CLAREMONT BUSINESS PARK 2 FIL. NO. 1 - LOT 7

EL PASO COUNTY, STATE OF COLORADO GRADING & EROSION CONTROL PLAN

EPC STORMWATER REVIEW COMMENTS
IN ORANGE BOXES WITH BLACK TEXT

GRADING & EROSION CONTROL PLAN
CLAREMONT BUSINESS PARK 2 FIL. NO. 1 - LOT 7
JOB NO. 44-037
DATE PREPARED: AUG 31, 2020
DATE REVISED:

GRADING & EROSION CONTROL PLAN
CLAREMONT BUSINESS PARK 2 FIL. NO. 1 - LOT 7
JOB NO. 44-037
DATE PREPARED: AUG 31, 2020
DATE REVISED:

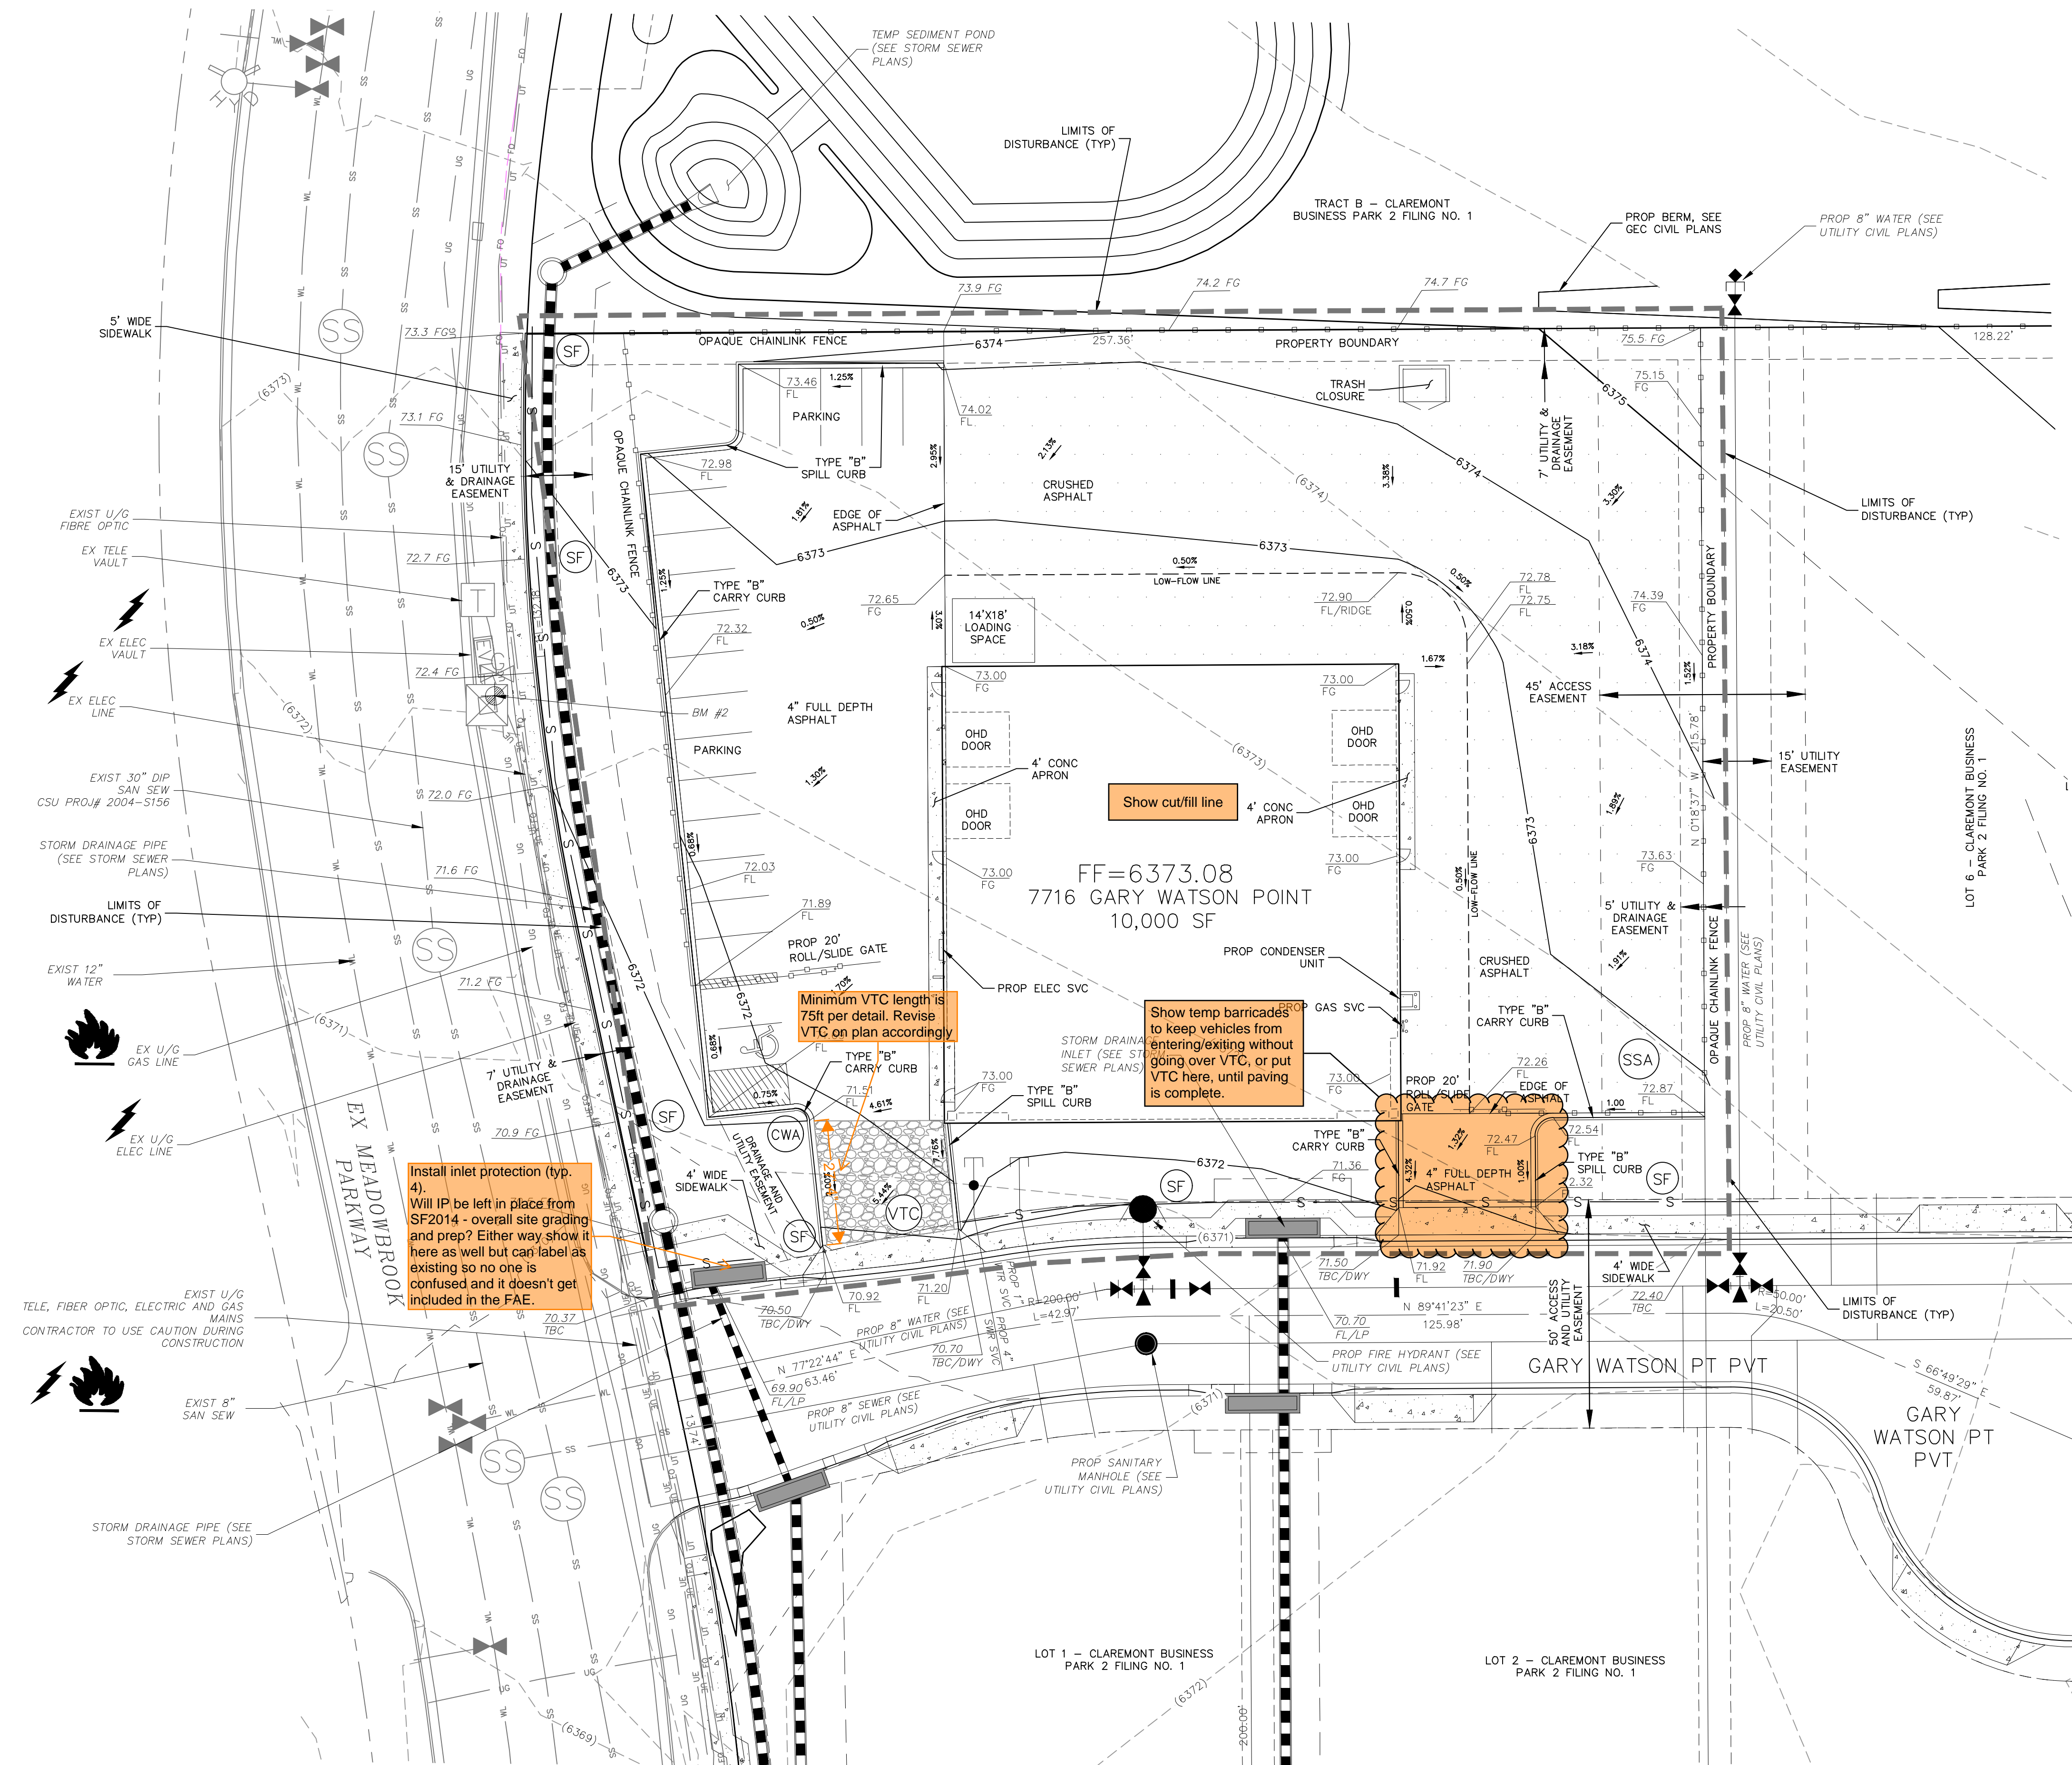
Item 1: include note about condition and type of existing vegetation

include details for CWA, Seeding/Mulching, SF, SSA, and VTC (w/ min 75ft length)

Install inlet protection (typ. 4'). Will IP be left in place from SF2014 - overall site grading and prep? Either way show it here as well but can label as existing so no one is confused and it doesn't get included in the FAE.

Minimum VTC length is 75ft per detail. Revise VTC on plan accordingly

Show temp barricades to keep vehicles from entering/exiting without going over VTC, or put VTC here, until paving is complete.

If same as Construction Boundaries, revise label to say: "Limits of Disturbance / Construction"

Add the following items to the Legend:
- Drainage flow arrows
- cut/fill line

Hatch areas to receive permanent seed/mulch and/or add a note stating the criteria for when/how/where seeding will be done (example: disturbed areas not being landscaped).
